UNITED STATES PATENT AND TRADEMARK OFFICE

APPLICATION NO.	FILING DATE	FIRST NAMED INVENTOR	ATTORNEY DOCKET NO.	CONFIRMATION NO.
10/605,660	10/16/2003	Sung-Fei Wang	10041-US-PA	2659

Office Action Summary	Application No. 10/605,660	Applicant(s) WANG, SUNG-FEI	
	Examiner Thinh T. Nguyen	Art Unit 2818

DETAILED OFFICE ACTION

FIG. 2

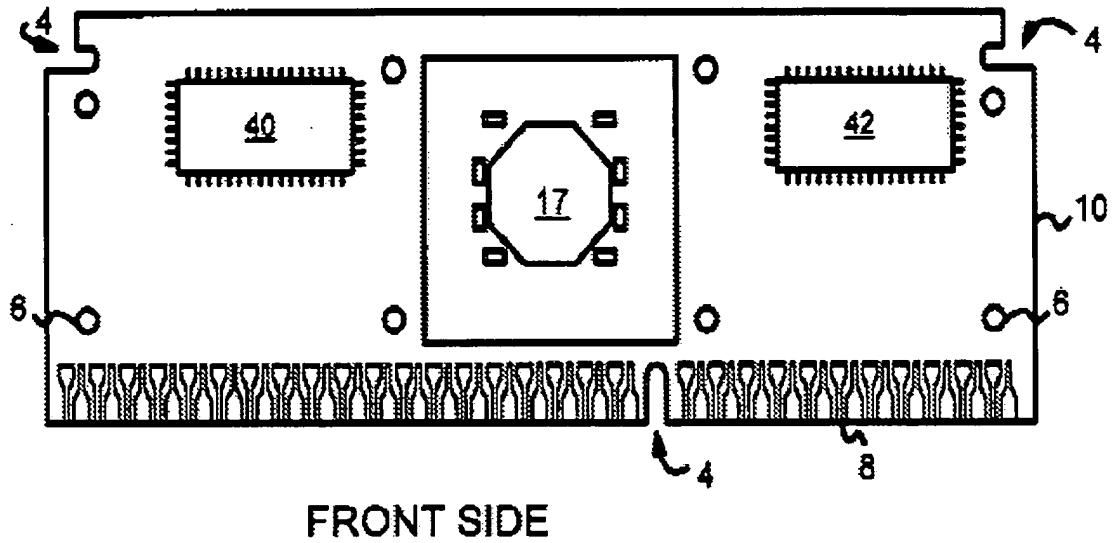
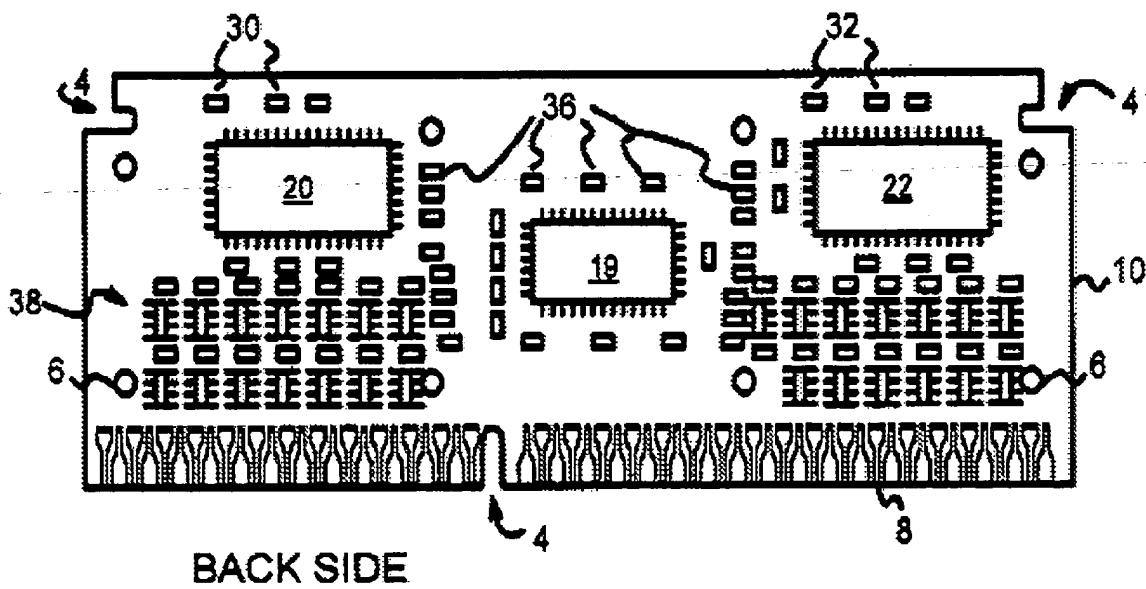
Chu (fig 2,the abstract) discloses a high density semiconductor package, comprising: a substrate, having a surface; a first package module (fig 2 reference 17,19), being disposed on the surface of the substrate; and a plurality of second package modules, being disposed on the surface of the substrate surrounding the first package module, wherein a corner of each of the second package modules face a side of the first package module and wherein the first package is coplanar with the second packages module.

FIG. 1

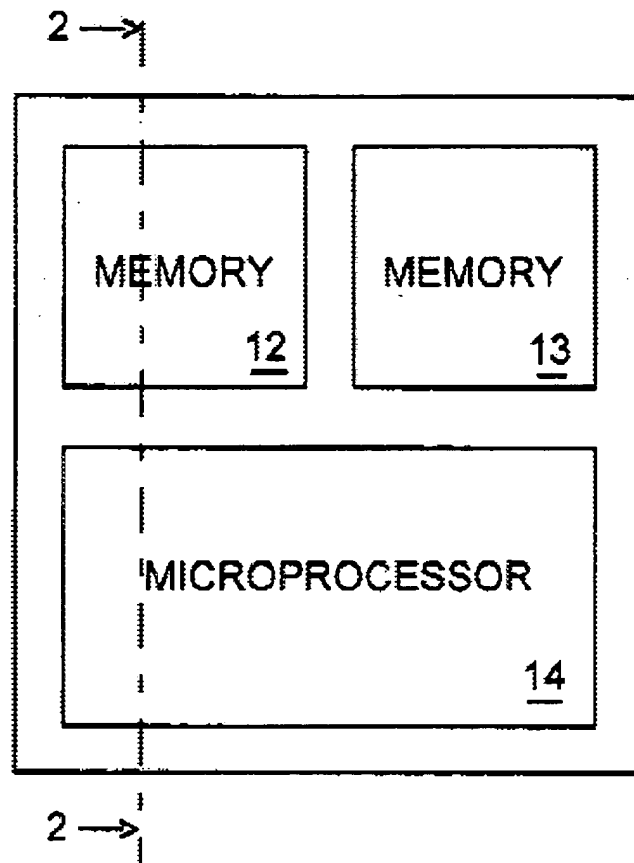
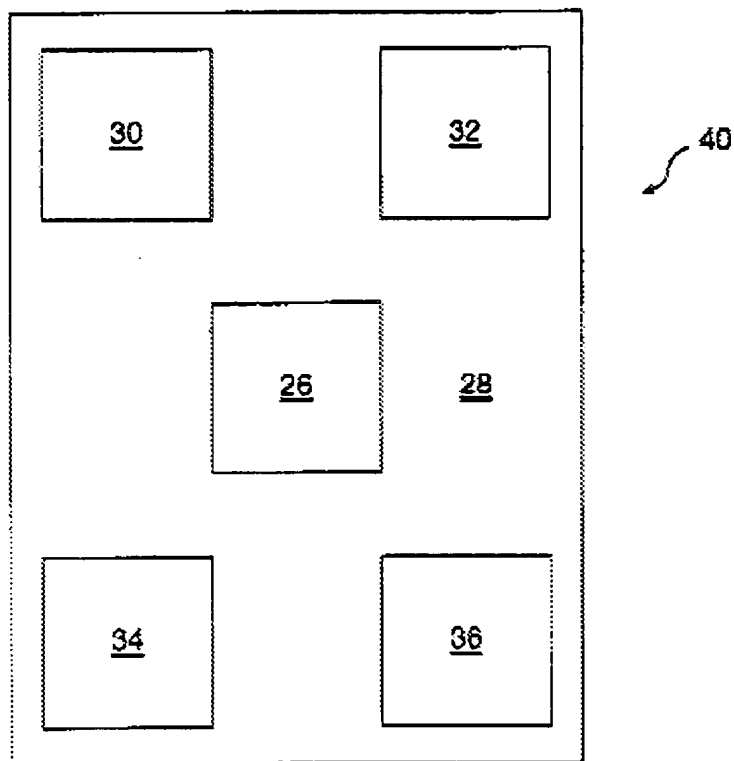
Similarly, Degani et al.(the abstract, fig 1) disclose the same invention.

Degani discloses (in the abstract, in fig 1) a semiconductor package wherein the first package module is arranged substantially non-orthogonal to the second package module.

FIG. 2

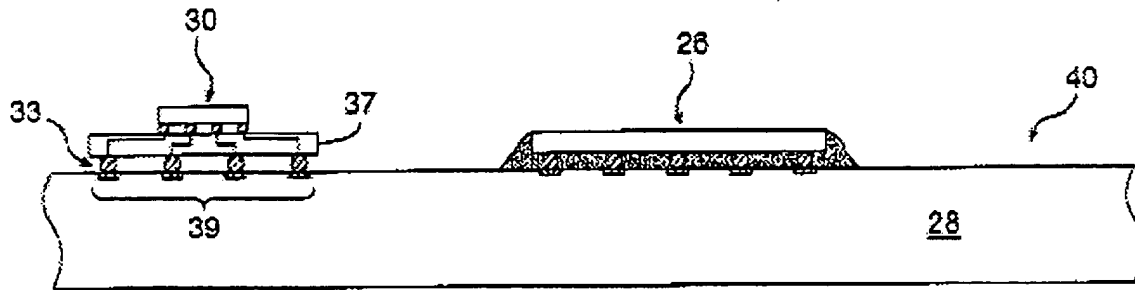
Degani discloses (in the abstract, fig 2,column 3 line 56) wherein the first package module comprises: a chip; a plurality of bumps located between the chip and the substrate; and an underfill located between the chip and the substrate and enveloping the bumps.

Degani discloses (in the abstract, fig 2,fig 3 chip 12 , column 3 line 56) wherein each of the second package modules comprises: a chip; a plurality of bumps located between the chip and the substrate; and an underfill located between the chip and the substrate and enveloping the bumps.

Degani et al (the abstract, fig 2, column 3 line 26) disclose all the invention including a underfill for all the chips and even though Degani do not disclose the gap between chips this gap
